APPLICATION NO. 18931

UNION PACIFIC RAILROAD (UPRR)

Bridge No. 143.71 Replacement,
Sutter County

January 23, 2015

PROPOSED VARIANCES (2/2)

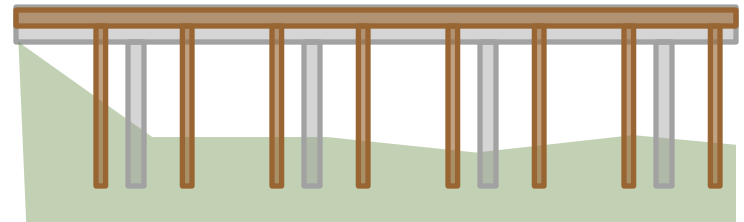
- §§ 128(a)(16) requires the bottom soffit of structural members of a replacement railroad bridge to be **no lower than the soffit of the existing bridge**
 - If designed to the existing soffit then UPRR would need to construct a substantial track raise (increased depth of the concrete deck), which would:

- Increase the total project cost by millions

Board staff has determined:

- UPRR has provided sufficient justification for the proposed variances
- the design does not cause any significant adverse impacts to the SRFCP
